**RE: TENDER FOR PROPOSED UMMA UNIVERSITY STUDENTS'
ACCOMMODATION FOR UMMA UNIVERSITY. TENDER NO. UUT/03/2026**

ADDENDUM NO. 02- CLARIFICATIONS AND REVISIONS

ELECTRICAL INSTALLATIONS
POWER SCHEMATIC 01

Scale :	N.T.S
Drawn By:	M. K. M.
Checked By:	Eng. I. M.
Description:	CONSTRUCTION
Date:	July 2026
Job No:	NI / 2607
Drawing No:	E - SC01

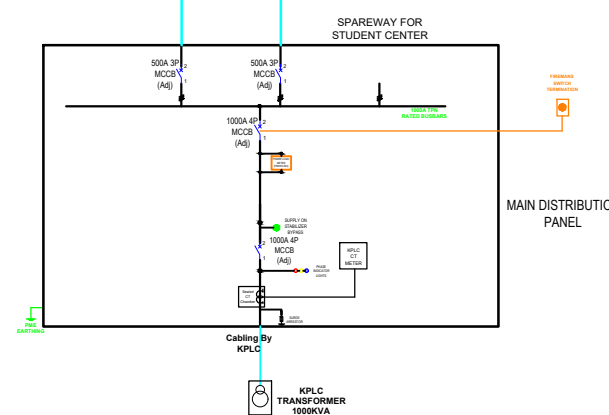
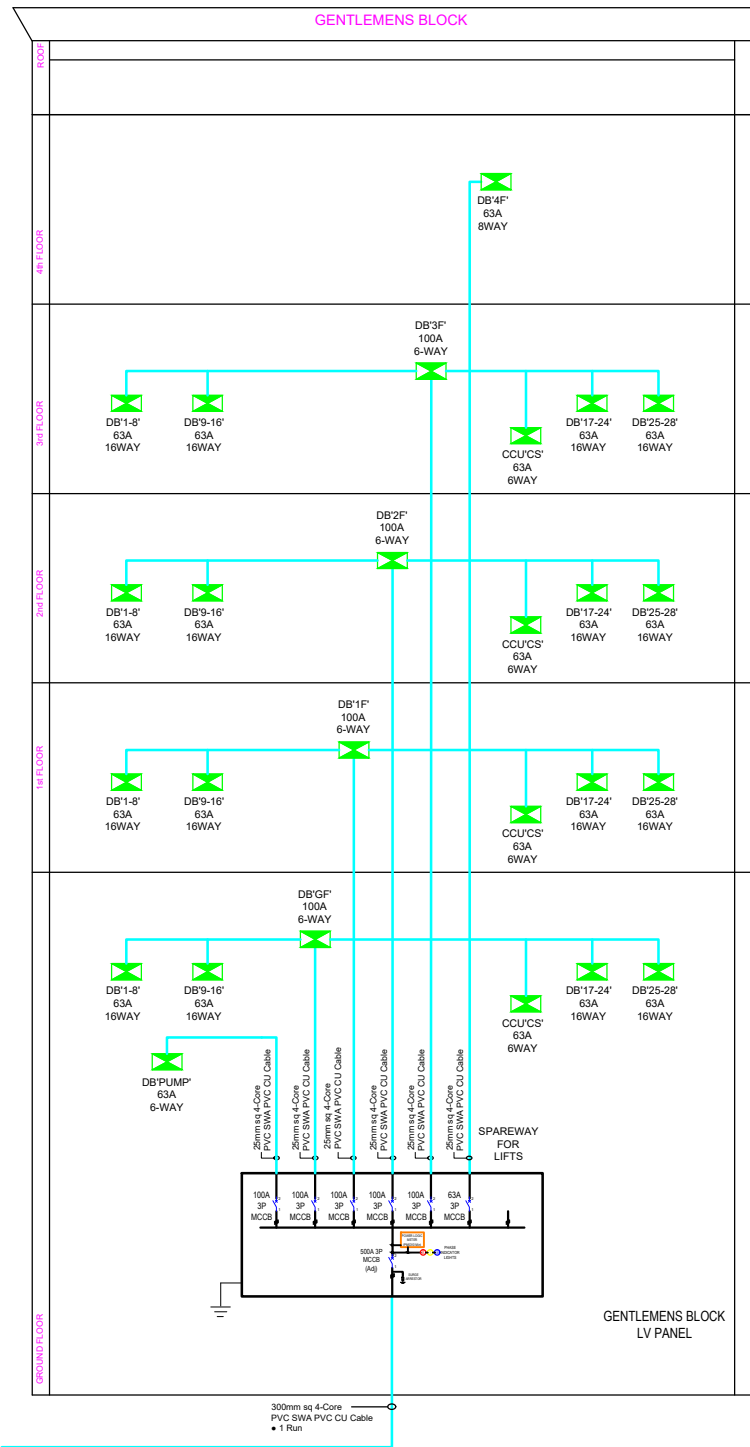
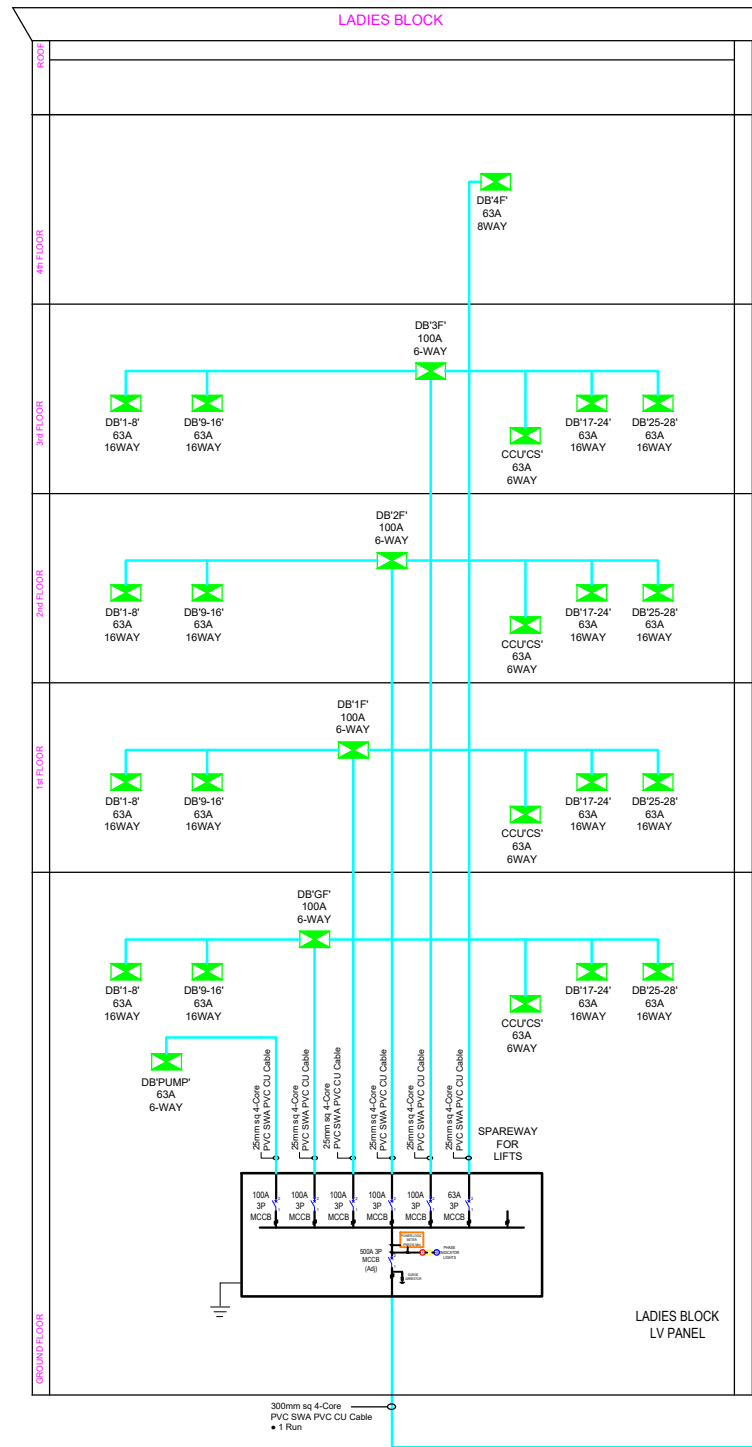
The risers will be supplied via copper cables.

Instant showers, lifts, lift accessories, generators, Student Center installations, power stabilization and pf correction were omitted.
